TAPS New Generation Receiver section - page 1

Revision: 1

Date: 120421

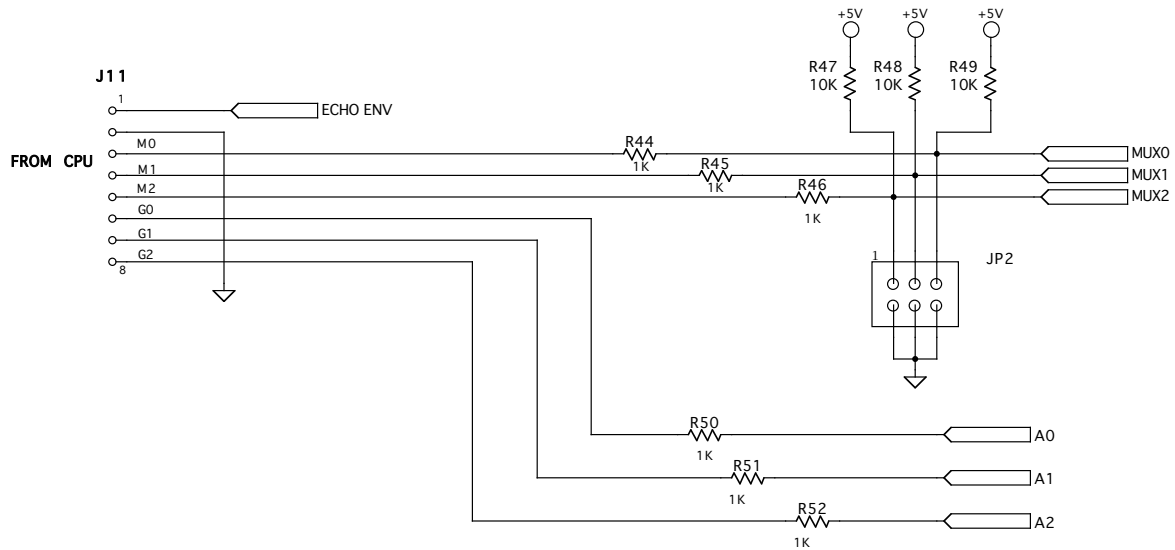
Add to card on solder side

Rev 1: Add C47 at U13 to reduce inverter frequency
